Addendum 1
Project No. 9557460, UCD Medical Campus Operating Rooms Modernization
Bid Packages 5.1, 7, 10, 17

This addendum to the RFP documents consists of page AD-1-1 thru AD1-3 and attachments. The following changes, additions, or deletions shall be made to the listed documents as indicated, and all other conditions shall remain the same.

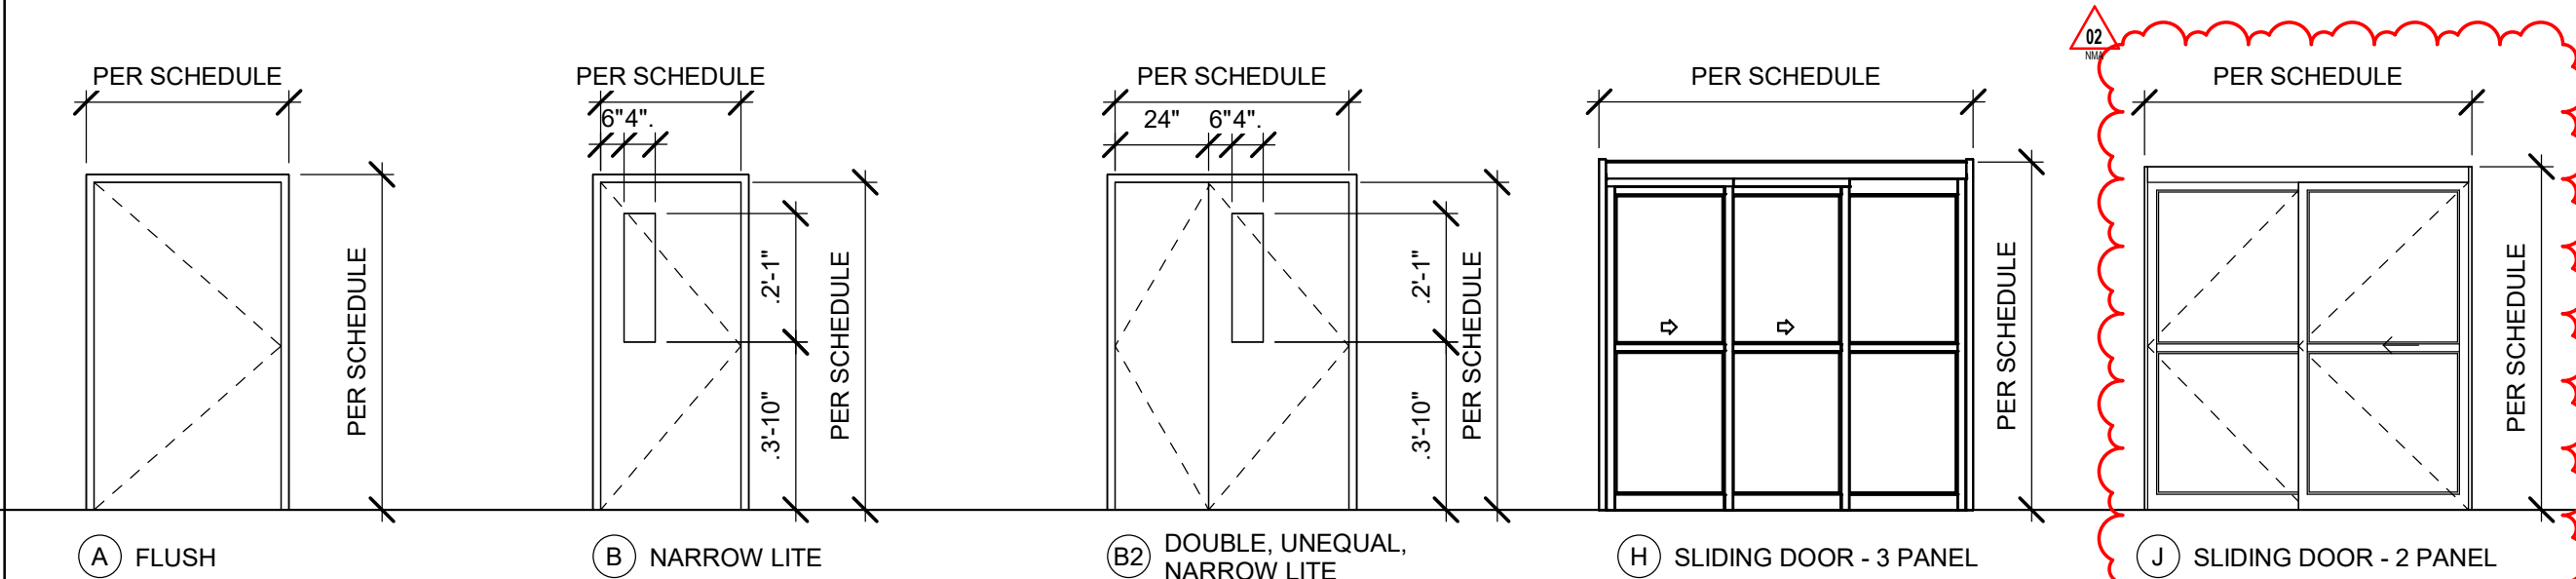
8. Question (BP-7, DFH): What is the lead requirement for the lead lined stainless windows and lead lined door 3P735X? It doesn't appear that the frame is to hold any lead lining, only lead glass, please confirm. Additionally what mechanism is to hold the glass in place as detail is unclear?

5. Question (BP-7, DFH): Please clarify which OR doors need closers replaced?

Response: Please refer to revised door schedule A-1601 for door & window properties. Also see A-1602 for head, jamb and sill details. See physicist report for additional information on lead requirements.

Response: See attached for highlighted scope exhibit where this is required. This is for the existing pair of doors on the dirty side section of each OR as specified on the door schedule. This is required at each of the 24 ORs.

door highlights represent where closers need to be replaced.

Shielded room is highlighted in pink. The clean core (adjacent to wall G) is highlighted in yellow.

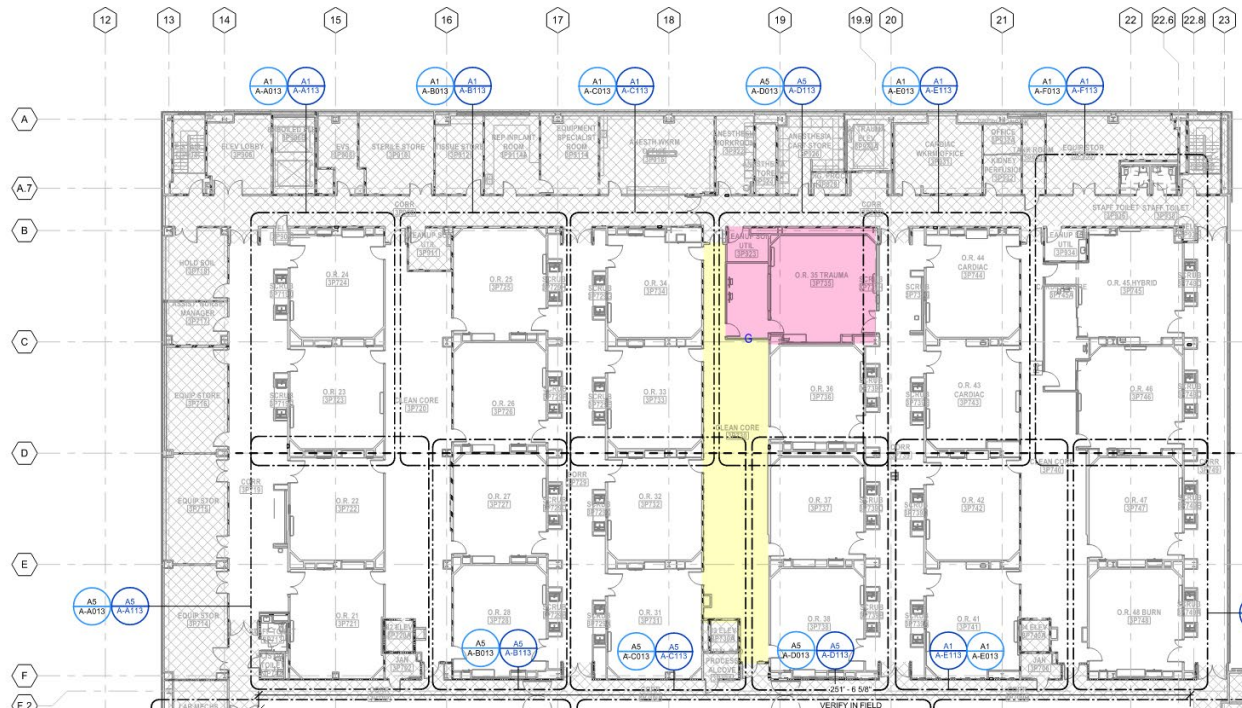
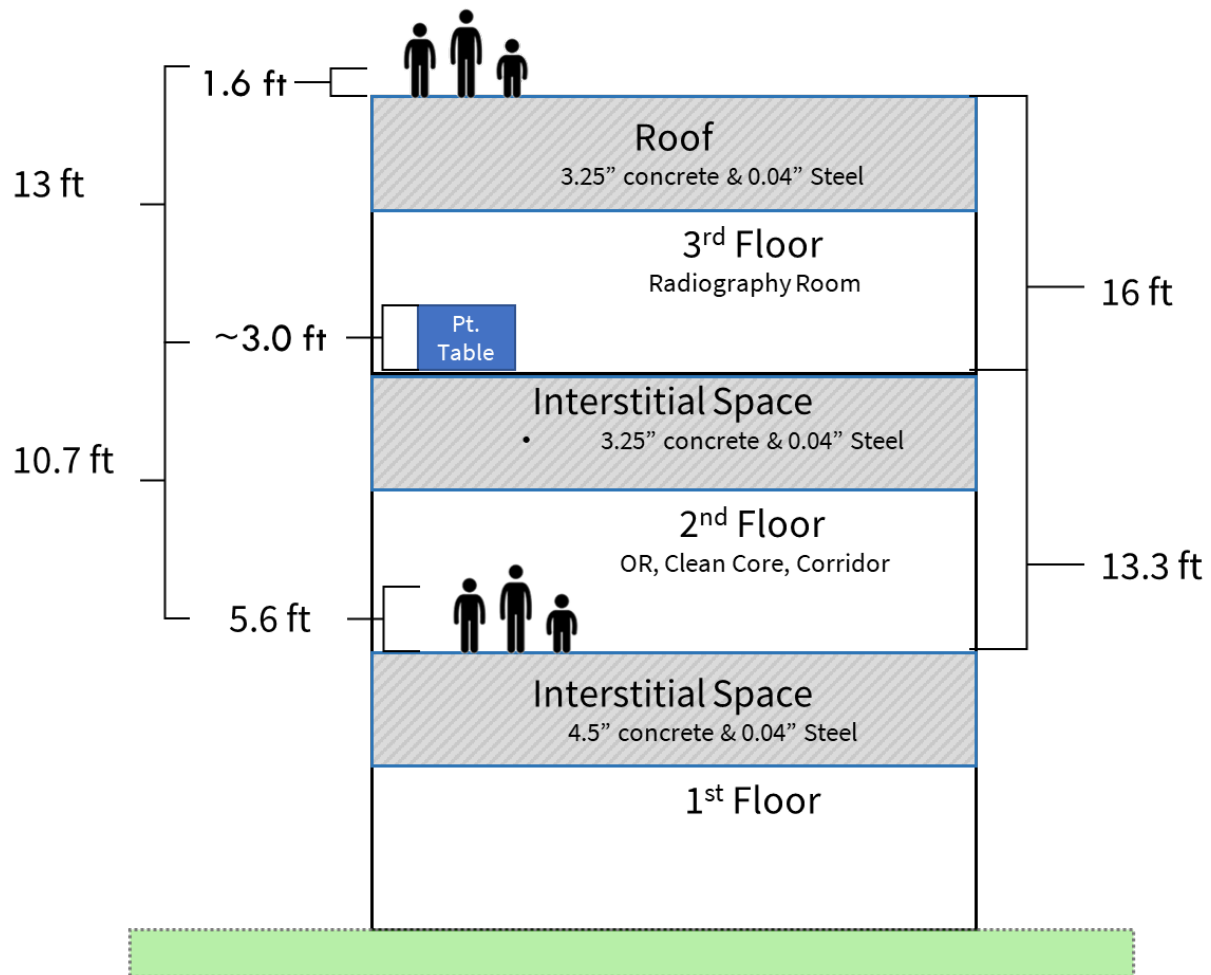
1. The proposed barrier for Wall G has been updated from 3 inches to 1.25 inches.
2. The adjacent space has been updated from "exam room" to "storage".
3. Therefore, **the barrier recommendation for Wall G is updated to proposed 1.25 inches drywall sufficient.**
